Proof of Evidence on Noise

Prepared by Rhys Scrivener of KR Associates (UK) Ltd
for Reading Borough Council

PROPOSED RESIDENTIAL DEVELOPMENT
55 VASTERN ROAD, READING

28th September 2021

Figure 06 – Screenshot of 1st floor Block BC residential layout

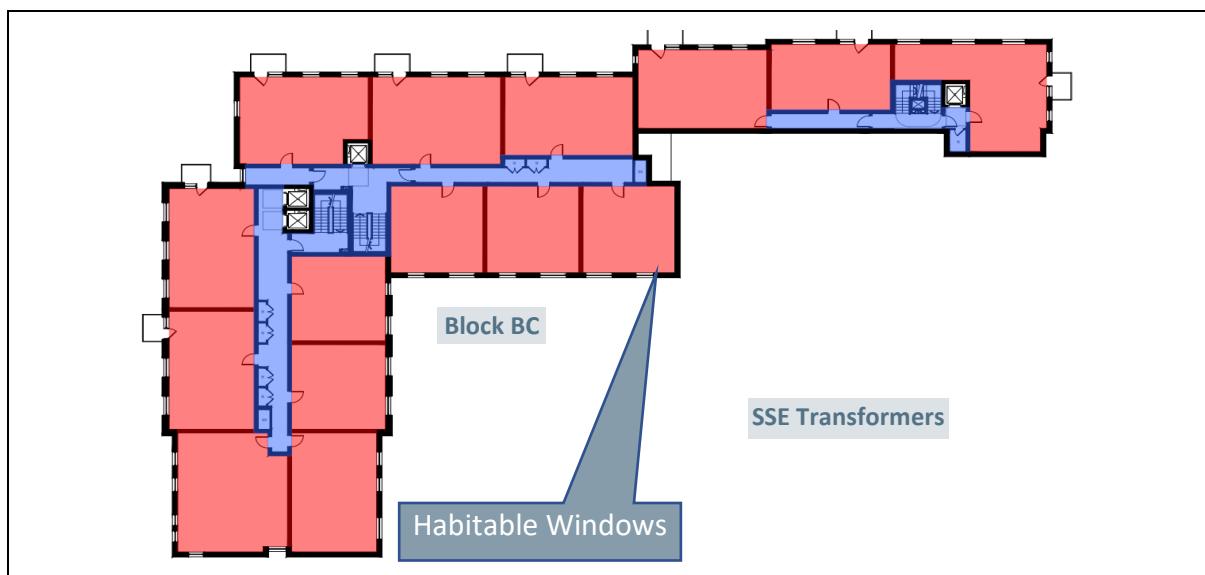
- 3.6 The following exert is taken from the Appellants general arrangement plan of the 1st floor of Block BC and shows the openable windows on the rear façade facing directly to the SSE Transformers.

Figure 14 – Frequency graphs of appellants sound power levels of SSE Transformers

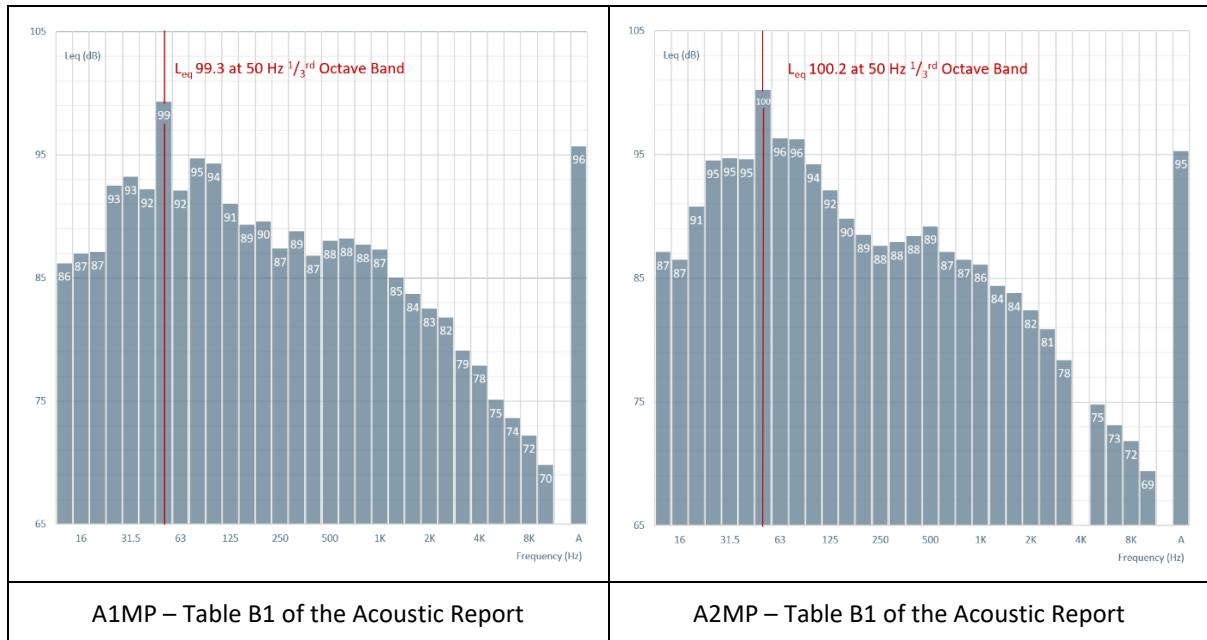
- 5.4 The following graphs show the 1/3rd octave band data for each of the SSE Transformers and the dominant tone within the 50 Hz and the secondary tone within the 100 Hz 1/3rd octave bands.

- 5.5 The Appellant within their Noise report only identifies at the 100 Hz tone and does not refer to the 50 Hz. The incoming supply to the SSE substations is likely to be 132 KV with the National Grid having a licence obligation to maintain a system frequency of 50 Hz +- 1% i.e., 49.5 Hz to 50.5 Hz.

Figure 15 – Comparison with Appellants 3D noise map

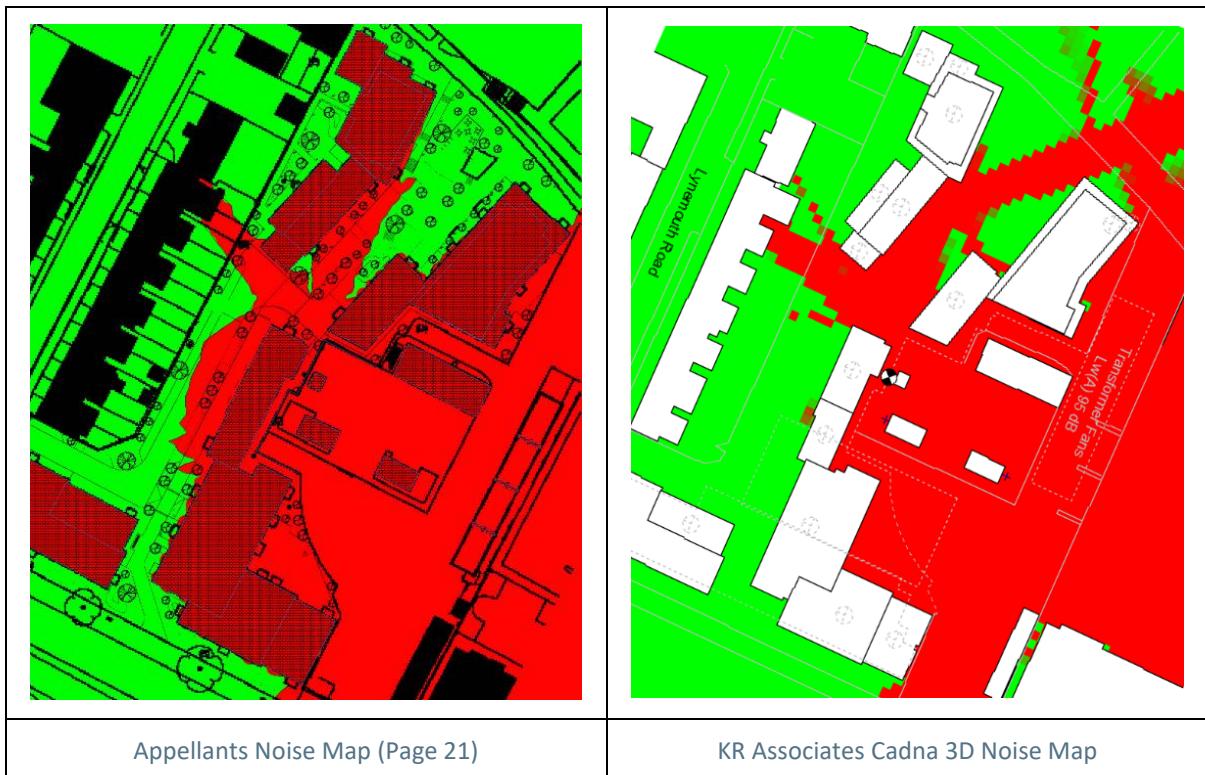
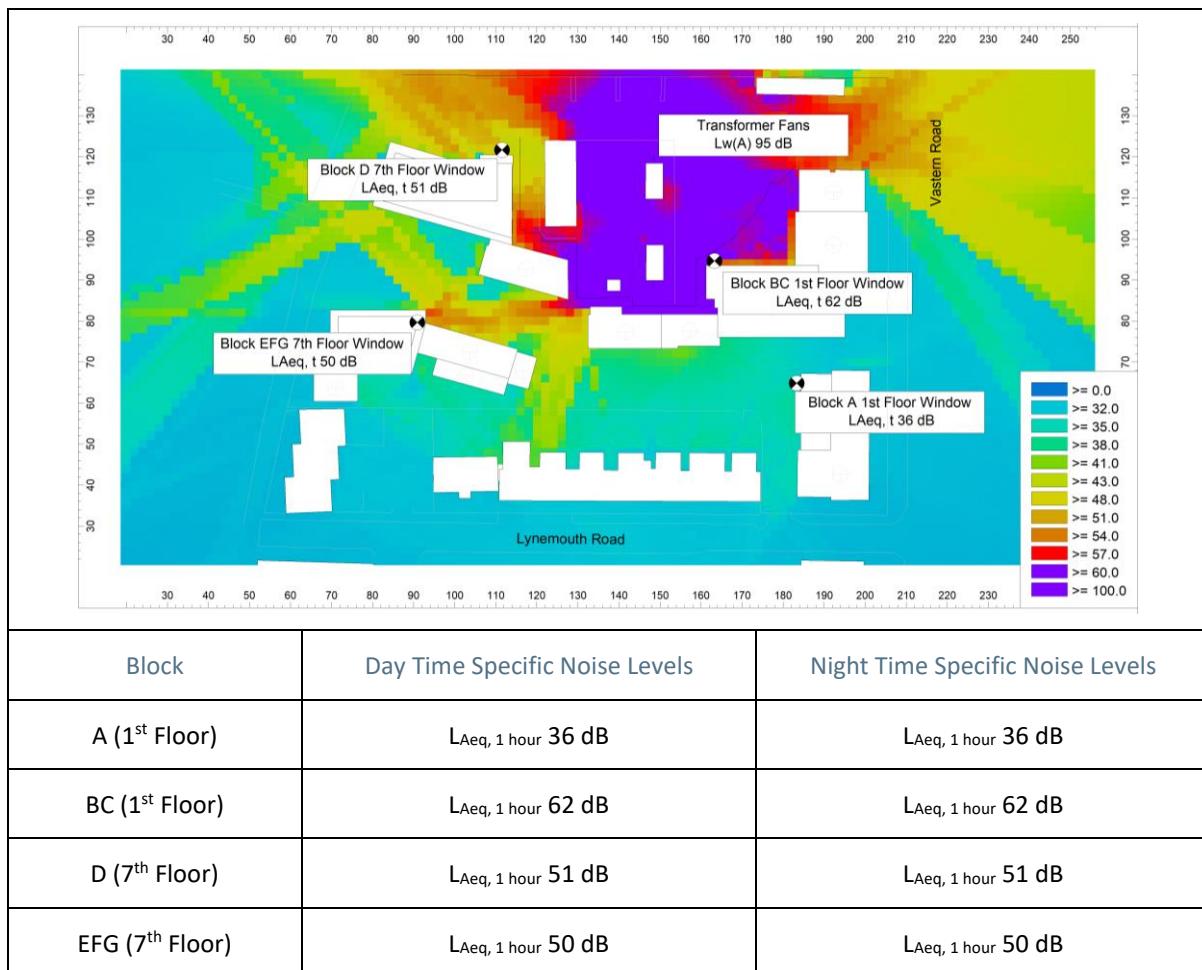
- 5.6 The Appellants noise report did not provide a 3D noise map of the transformer noise levels and how they impact the facades of the four main buildings. However, the Appellant did provide “Drawing Number Figure 4” on page 21 of the report which showed a 3D noise map with the overall A-weighted generator levels that were over LAeq 41 dB in red and that were below L_{Aeq} 41 dB in green. 3D noise maps provide a useful visual tool to fully understand and appreciate how noise interacts with complex arrangements of buildings at different heights and angles to the noise source.

5.7 To provide a comparison with the Appellants noise map I calculated the same noise map assuming each building façade was constructed from brick and glass.

5.8 The following noise maps show a good correlation between the Appellants 3D noise map and the noise map which I am using to calculate the overall noise levels.

Figure 18 – Appellant's background noise level graph

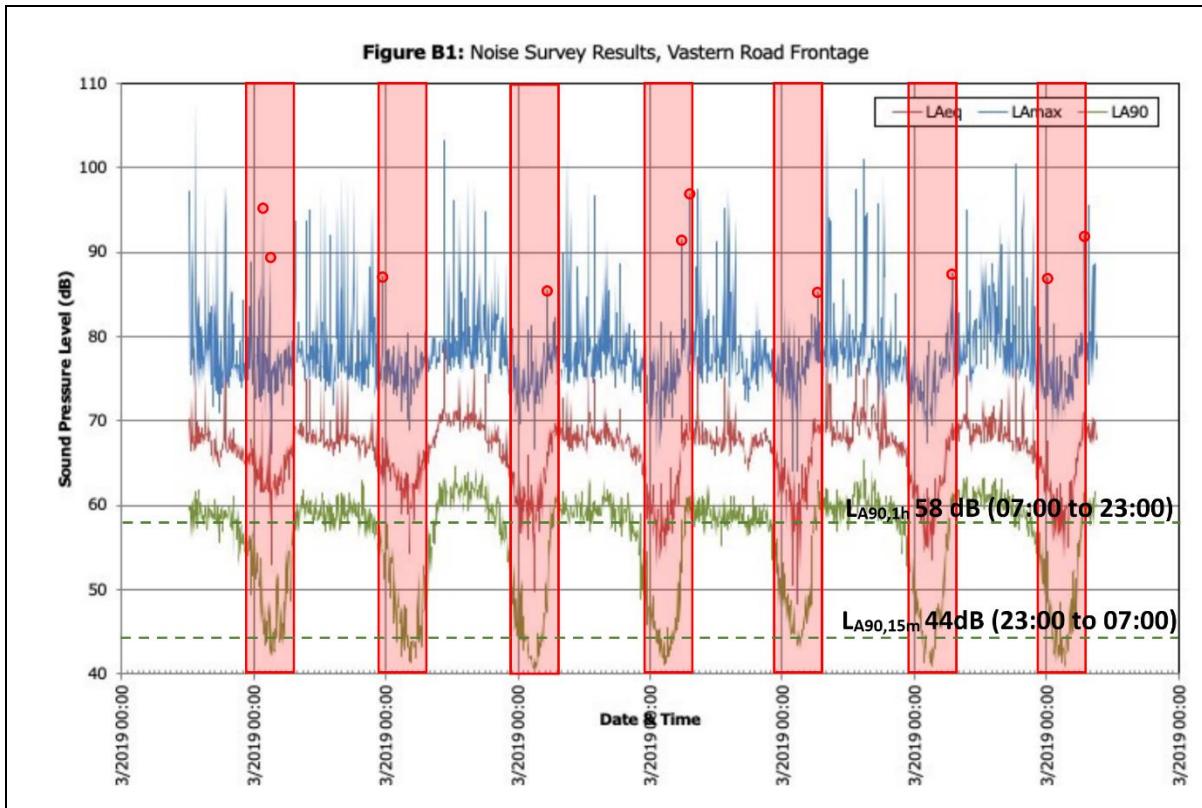
- 5.12 However, the Appellants did not report the background noise levels within the day and night time periods at this measurement position within their report.

- 5.13 I have therefore over-laid the approximate night time periods as transparent red squares and provided an approximation of the likely modal background noise levels. In my professional experience I would expect this estimate to be within 2 or 3 dB.

Figure 28 – 1/3rd octave band façade levels from the SSE Transformers.

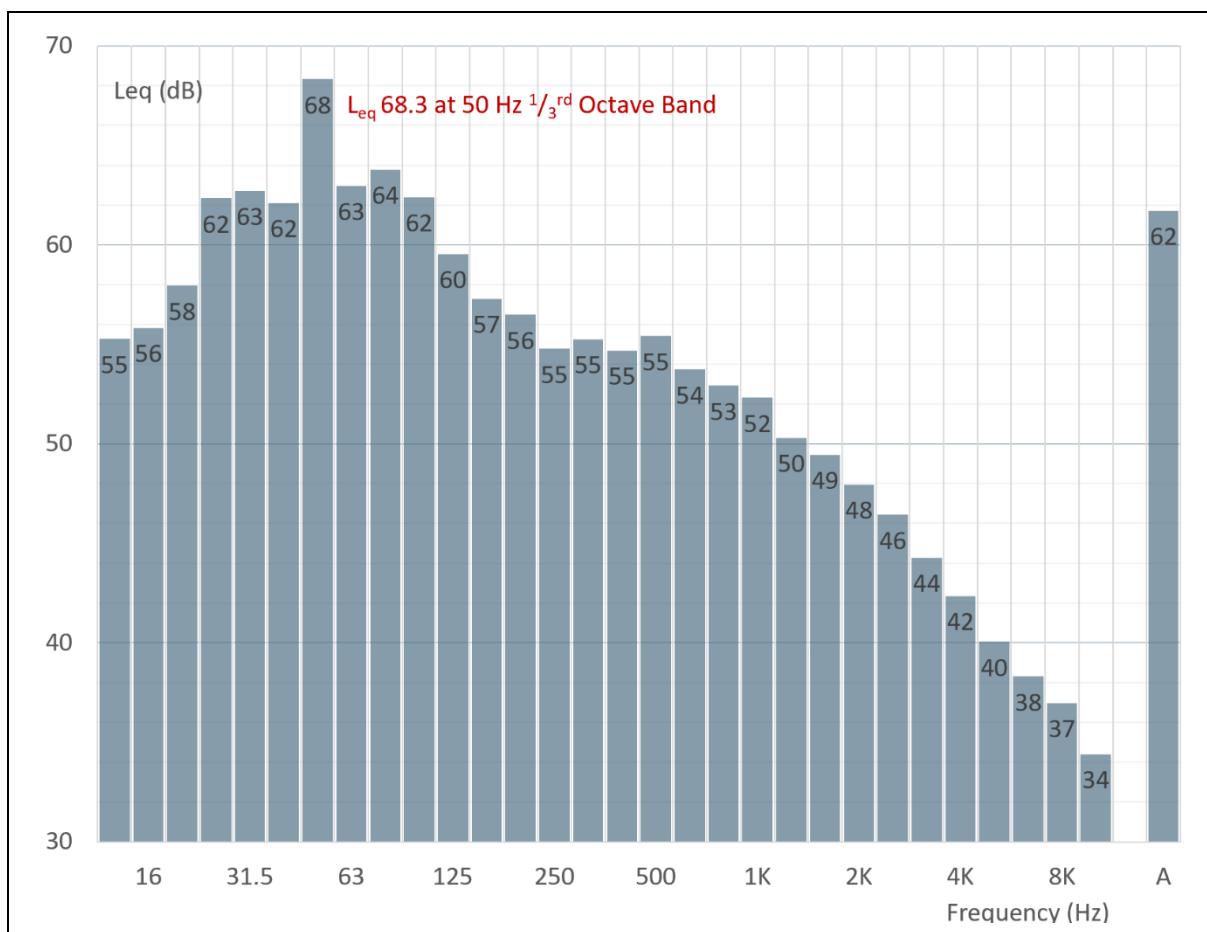
- 6.2 The following graph shows the resultant 1/3rd octave noise levels that will impact the rear of Block BC at 1st Floor level which clearly shows the 50 Hz tone from the SSE Transformers.

Figure 30 – Resultant low frequency internal noise levels.

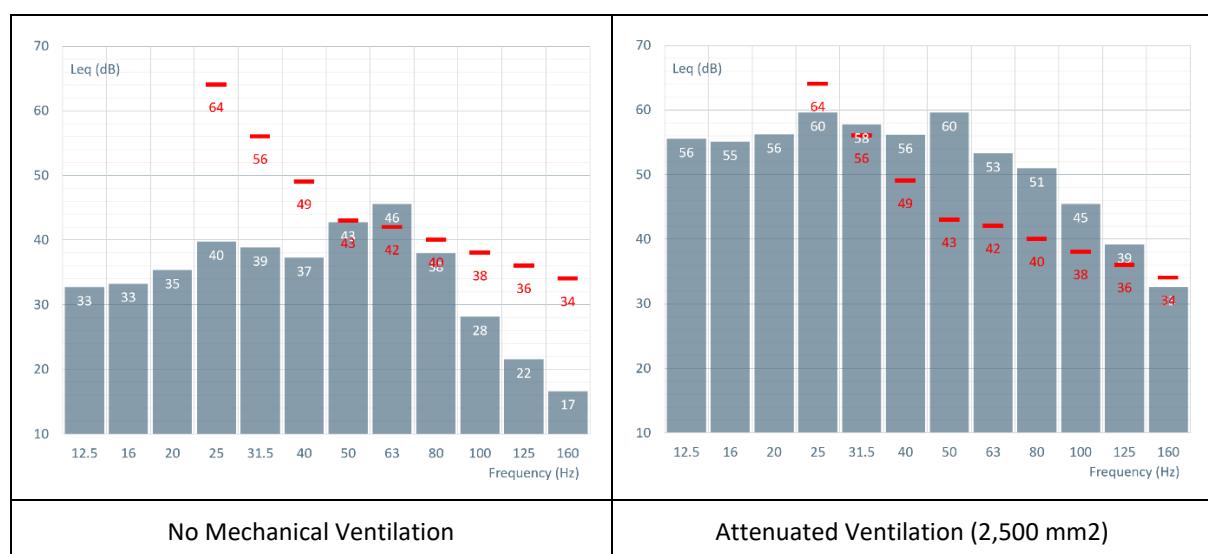
- 6.9 The first graph on the left shows the internal level if all the mechanical ventilation was blocked up and the façade just consisted of brick and glazing. The graph on the right shows the internal levels with a fully attenuated MVHR system operating. For reference the NANR 45 criterion curve is shown in red on both graphs.

6.10 The above graphs demonstrate that the resultant noise levels with the windows closed will exceed the criterion within NANR45 which indicates that complaints are likely to be received.
